VOLUME 13

Supplemental

Submission

907010: RKD 3311/303845

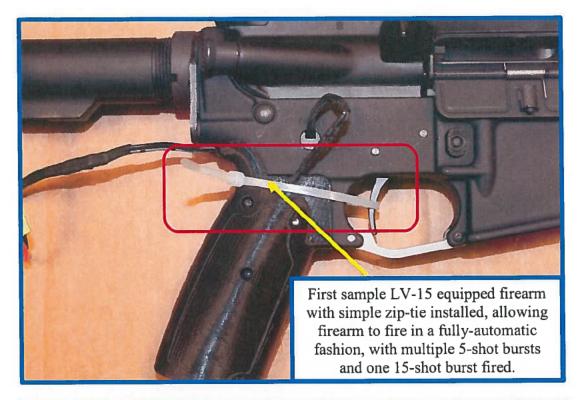
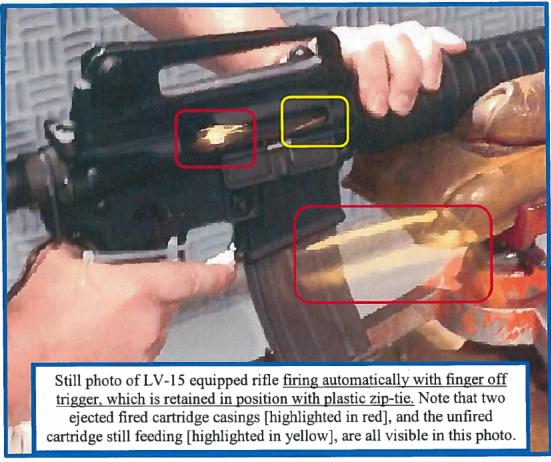
When the trigger was pulled <u>slowly</u> and retained in a position at which the hammer was just release with the device actuated during manual field testing, a condition resembling automatic cycling was observed on several occasions, during field testing of the LV-15 equipped firearm. Actual test firing with live ammunition replicated this same condition.

In order to ensure that the LV-15 equipped firearm was actually firing more than one shot, without manual reloading, with a single function of the trigger, rather than firing a single shot with each function of the trigger, the following procedure was followed.

FTISB testing with the trigger of the LV-15 equipped firearm pictured on the previous page, retained in the static position shown with a plastic zip-tie, revealed that the LV-15 device could allow a semiautomatic AR-15 type firearm to fire automatically more than one shot, without manual reloading, by a single function of the trigger.

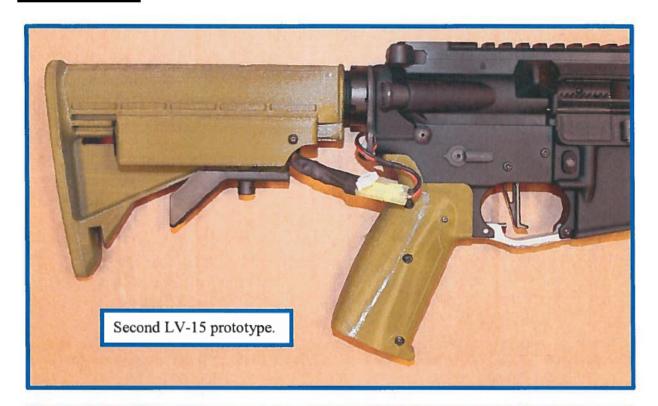
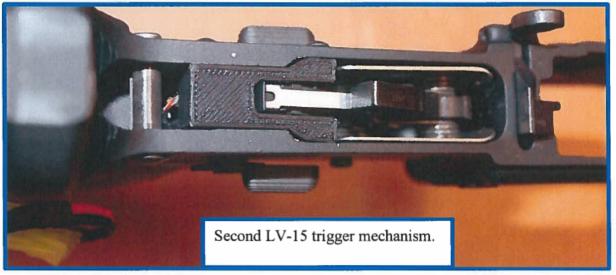
To initiate firing using the LV-15, a shooter must simply pull the trigger (photo 1—note that the solenoid rod is inside the firearm. These photos show the approximate location of the rod in the firearm. This is done simply to explain the functioning of the device). After firing, and when the bolt has loaded a second round of ammunition (photo 2-3), the mechanical-electrical operation of the LV-15 trigger device utilizes a "solenoid rod" to push the trigger forward as if the shooter had released the trigger (photo 4). Although the trigger is pushed forward the shooter never releases the trigger. Pursuant to your explanation, the shooter must merely maintain a pull that exerts "not more than 12 pounds of force during said 15 millisecond interval." If the shooter maintains this pressure, a second shot is fired (photo 5). As stated above, firing requires so little input from the shooter—a single pull with constant pressure—that a zip tie can effectively fire a weapon utilizing the LV-15 until the ammunition source is exhausted. A shooter need only pull the trigger once to initiate firing, and the LV-15 then operates automatically to continue firing.

This Branch approved these devices, but this was in spite of the fact that the devices utilize a "single function of the trigger." As was explained in those classification letters, these items were not classified as machineguns because the stocks had no automatically functioning mechanical parts or springs and performed no automatic mechanical function when installed. A weapon is a machinegun if it shoots, is designed to shoot, or can be readily restored to shoot, *automatically* more than one shot, without manual reloading, by a single function of the trigger. Because the shooter was required to provide the forward pressure with his hand, the firearm did not function "automatically." The LV-15 does operate automatically, as it uses an electrical-mechanical device to automatically cycle the trigger forward against the initial trigger pull, thus allowing the LV-15 equipped firearm to automatically fire.
